RE: Modification to a Risk-Based Soil Cleanup Plan
Maine Energy, Biddeford, Maine

MODIFICATION TO A RISK-BASED CLEANUP PLAN

PROJECT: MAINE ENERGY RECOVERY COMPANY- PCB REMEDIATION

SHEET TITLE: SOIL VERIFICATION SAMPLING RESULTS EXISTING FLOOR

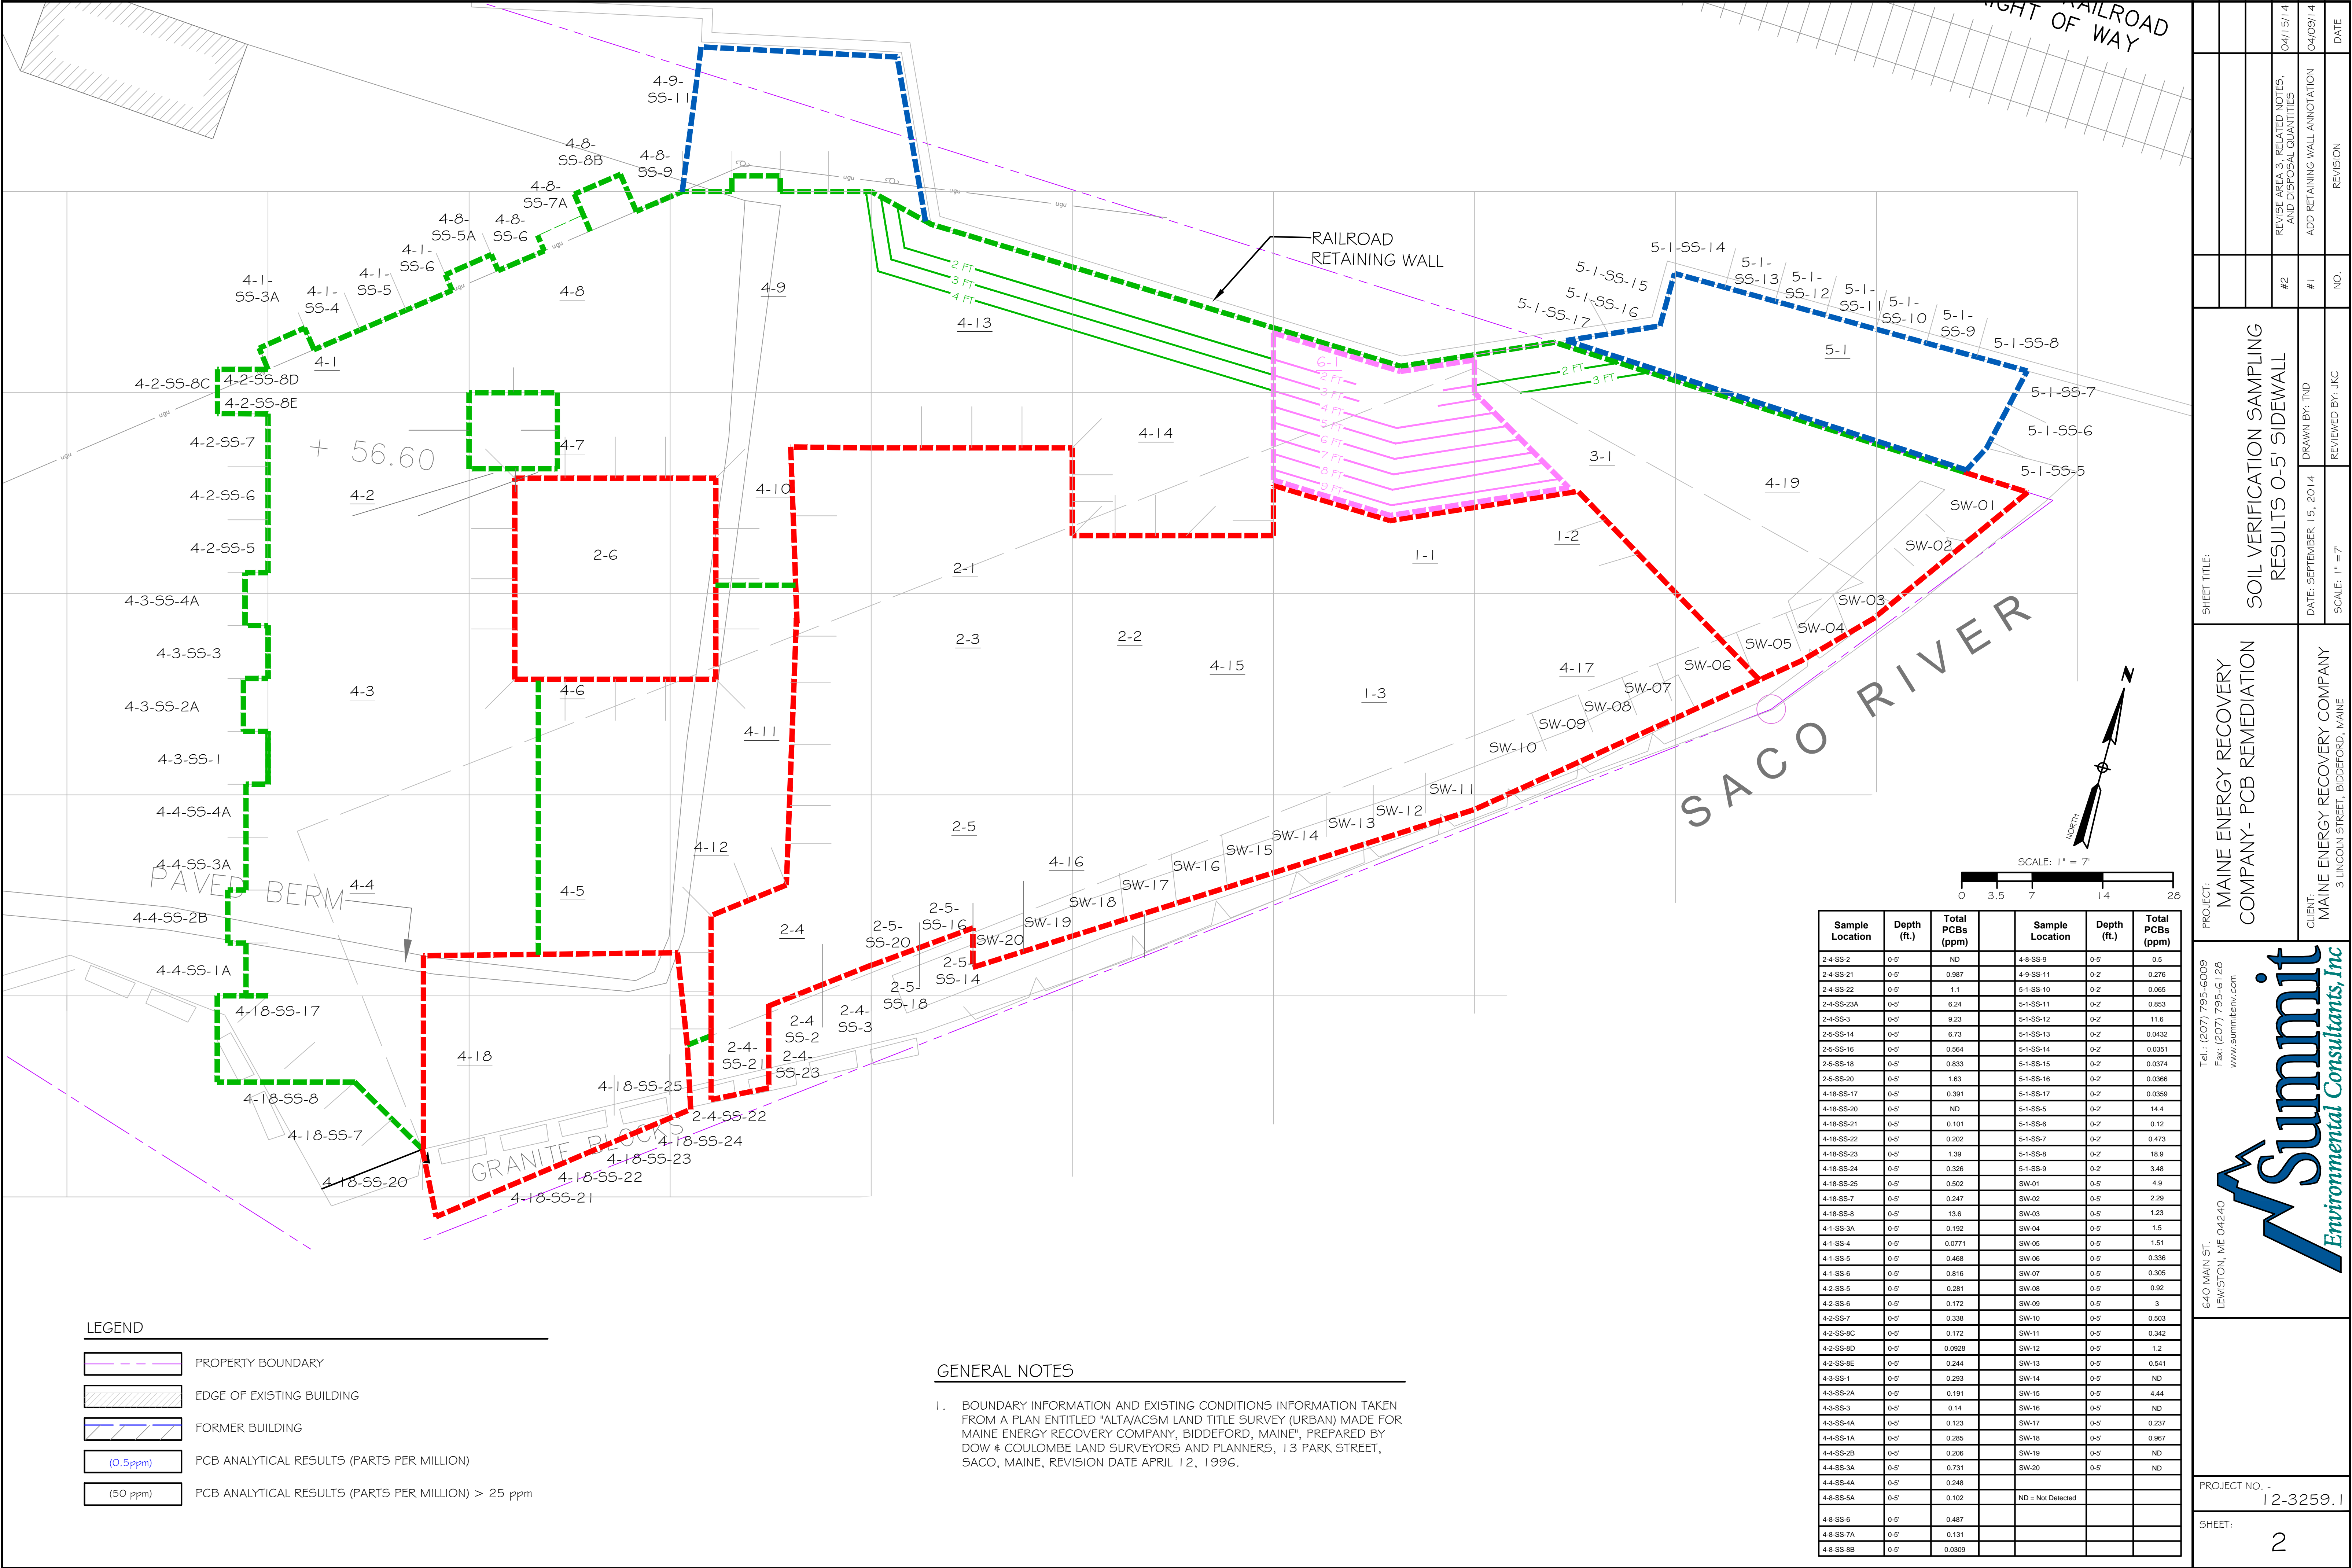
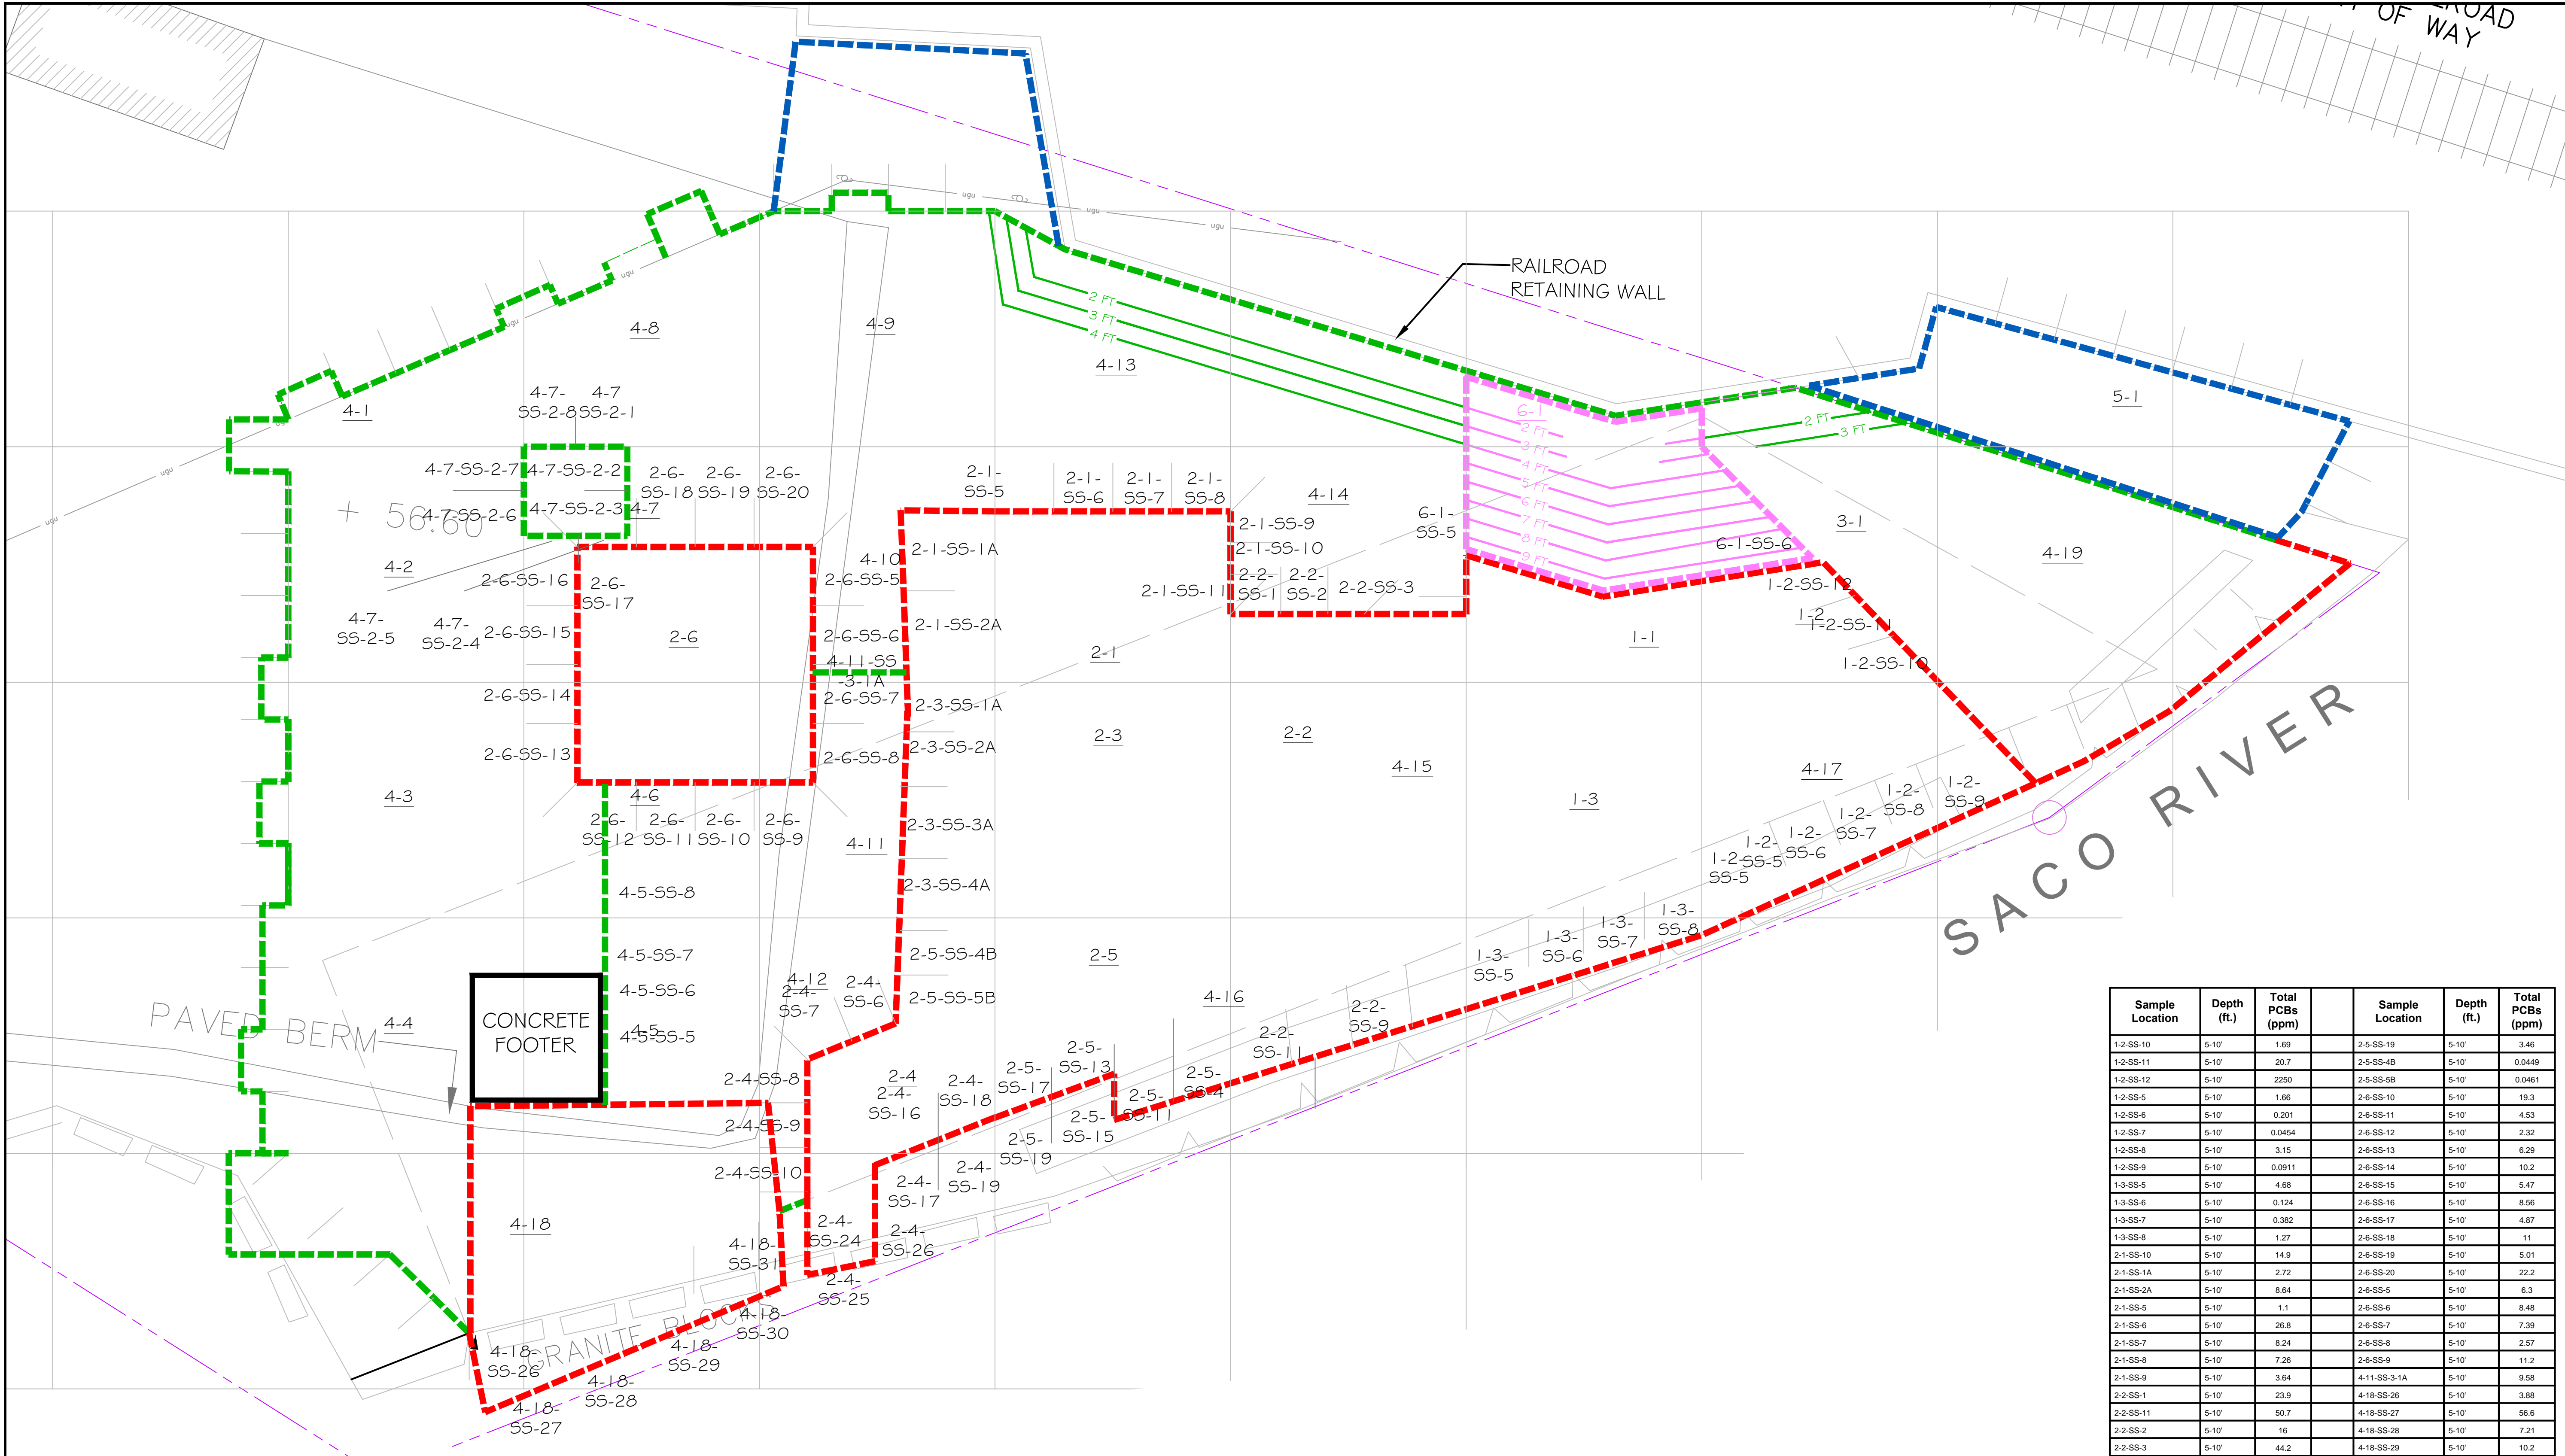
As can be seen on the attached plans, soil verification sampling completed to date indicates areas that have met the original cleanup goal, areas where excavation activities are still ongoing to meet the cleanup goal of 25 ppm, and those areas with structural considerations which have limited our ability to get to the cleanup goal.

This Plan modification requests approval to backfill the excavation to stabilize the site in areas where PCB concentrations are <25 ppm, further excavation is limited due to structural concerns, or the excavation depth is just above groundwater. Backfill in this context is limited to installing the requested overlapping polyethylene sheeting and then backfilled per our original specification with common borrow extending from the polyethylene to four feet below grade.

Once the remainder of the soil in the western portion of the site has been excavated (see site plan 1) leaving PCB concentrations <25 ppm as demonstrated by verification analysis or the depth of the excavation is limited by proximity to groundwater, this area will be covered with overlapping polyethylene sheeting and covered with common borrow to match the backfill layer on the eastern side of the excavation. Twelve inches of barrier soil will be placed from 3 to 4 feet over remaining impacted soil and/or backfill. A 40-mil textured high density polyethylene (HDPE) geomembrane liner will overlie the barrier soil layer and be installed in accordance with manufacturers recommendations by an experienced installer. A drainage geocomposite layer comprised of bi-planar HDPE netting sandwiched between non-woven geotextile filter fabric will overlay the geomembrane. Geocomposite will extend over the limit of the cap and be installed according to manufacturer's recommendations by an experienced installer. In addition to conveying surface water away from the excavation area, the HDPE netting and geotextile fabric provides a physical protective layer over the geomembrane.
